Access Compliance Report

Public Rights-of-Way

Intersection ID: 19934	Main Street: W_ARROWWOOD_RD	Cross Street: WHITEWHITEHALL_EXECUTIVE_CENTER_DR	Location: SE
ADA ID: 28A22908A24E	Ramp Type: Perp	Initial Pass/Fail: Pass	Overall Compliance: No Severity Score: 0
Codes/Mitigation Info/Possible Solution		Field Measurements/Component Compliance

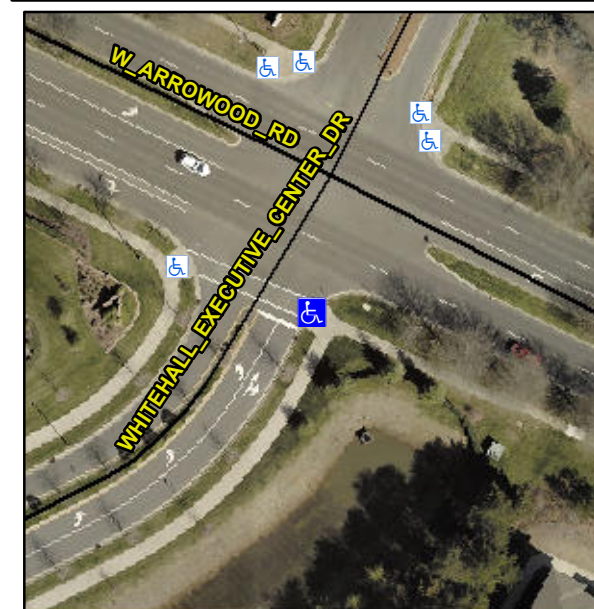
R304.2.1, R305.2

Compliance	Description	Data	Compliance	Description	Data
N/A	Ramp Length (in)	96.0	Yes	Ramp Slope (%)	6.6
Yes	Ramp Width (in)	48.0	Yes	Ramp XSlope (%)	0.7
N/A	Flare Type LT	Sloped	N/A	Flare Type RT	N/A
N/A	Flare Slope LT (%)	7.4	Yes	Flare Slope RT (%)	6.4
N/A	Flare Traversable LT?	Yes	N/A	Flare Traversable RT?	Yes
Yes	Landing Length (in)	60.0	Yes	DWS Provided?	Yes
No	Landing Width (in)	47.0	Yes	DWS Contrast?	Yes
Yes	Landing Slope (%)	2.0	Yes	DWS Length (in)	24.0
Yes	Landing X Slope (%)	0.2	Yes	DWS Full Width?	Yes
N/A	Landing Curb? (Y/N)	No	No	DWS Offset (in)	2.5
N/A	Shared Landing?	No			
Yes	Gutter Ponding?	No	Yes	Gutter Slope (%)	2.1
Yes	Gutter Lip Ht (in)	0.0	Yes	Gutter X Slope (%)	0.1
N/A	Painted X Walk1?	Yes	N/A	Painted X Walk2?	N/A
	X Walk 1 Direction	To NW		X Walk 2 Direction	N/A
N/A	X Walk 1 Width (in)	109.0	N/A	X Walk 2 Width (in)	N/A
	X Walk 1 Slope (%)	0.1		X Walk 2 Slope (%)	N/A
	X Walk 1 X Slope (%)	1.1		X Walk 2 X Slope (%)	N/A

Yes	Ramp inside XWalk1?	Yes	N/A	Ramp inside XWalk2?	N/A
	Road Slope (%)	N/A	N/A	Clear Space?	Yes
	Road X Slope (%)	N/A	N/A	Clear Space to XWalk (in)	N/A
Yes	Any Obstructions?	No	Yes	Storm Grate/Utility Hazard?	No
	Obstruction Type			Storm Grate/Utility Type	
		N/A			N/A
			Yes	Surface Condition? (G/P)	Good

Remove & Replace Entire Ramp.
